**Re: Sunset West Unit II Lots 16, 26 and 27 Grading and Drainage Plan
Engineer's Stamp date 8-26-10 (M09/D004A)**

SUBJECT: *SUNSET WEST, UNIT 2*
TEMPORARY RETENTION POND RECLAMATION IMPROVEMENTS
L09/D004A
CPN 499182

SUNSET WEST UNIT II LOTS 16, 26 AND 27
GRADING AND DRAINAGE PLAN

① STREET DEPTH CHECK

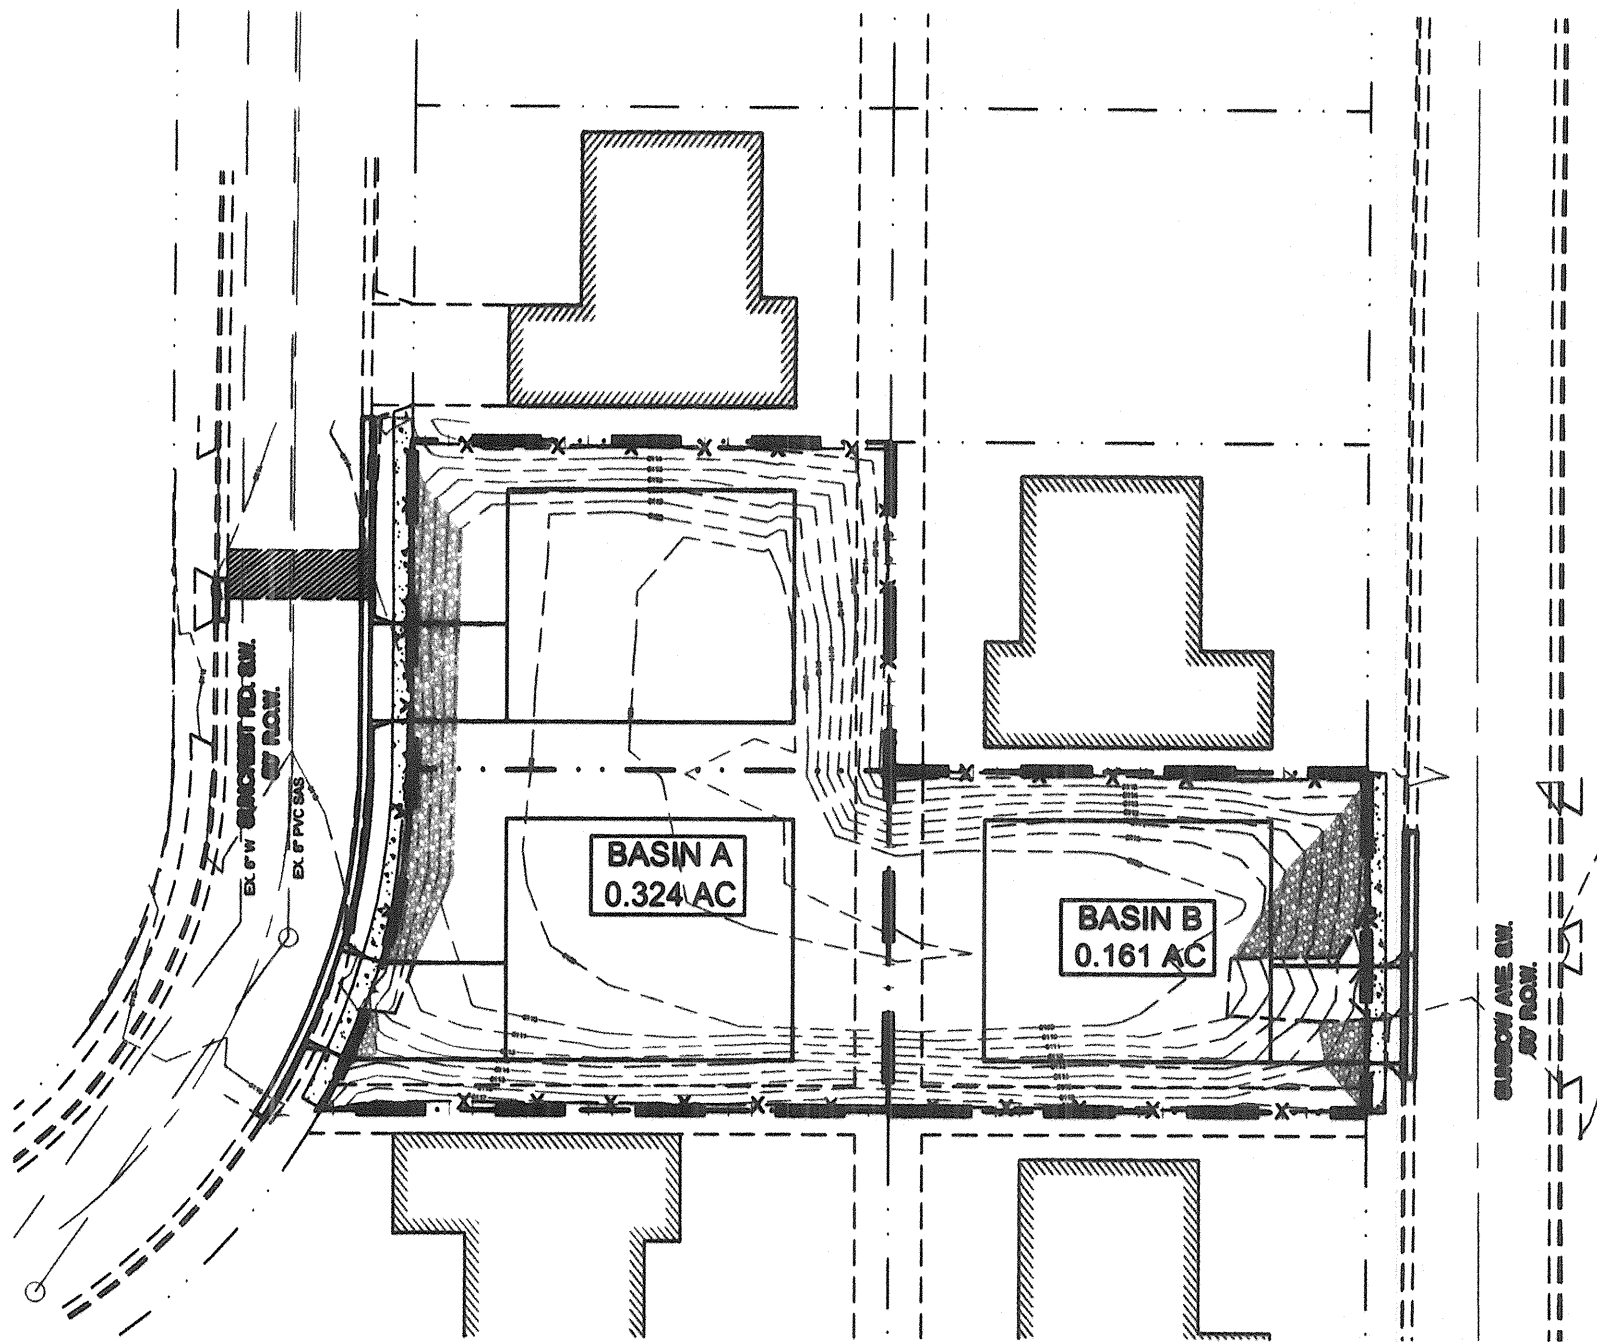
1. We understand that Work Order will not be issued until completion of the 86th/Sage Storm Drainage Project.
2. We propose to construct an earthen berm and repair the existing asphalt curb along the east side of 90th street to improve street carrying capacity. See attached calculations and details.
3. The Keyed Notes have been revised to identify public-vs-private work items.

① AT TOP OF CURB

$$\begin{aligned} Y &= 0.67' \\ S &= 0.9\% \\ n &= 0.017 \end{aligned}$$

$$\Rightarrow Q = 73.5 \text{ CFS} \\ V = 5.6 \text{ F/S}$$

top of curb R/W
 $73.5 < 90 < 113.6$

② AT R/W (WEST)

$$\begin{aligned} Y &= 0.83' \\ S &= 0.9\% \\ n &= 0.017 \end{aligned}$$

$$\Rightarrow Q = 113.6 \text{ CFS} \\ V = 6.4 \text{ F/S}$$

$\Rightarrow Q_{100} = 90 \text{ CFS}$ - WILL TOP THE CURB BUT STAY WITHIN ROW.
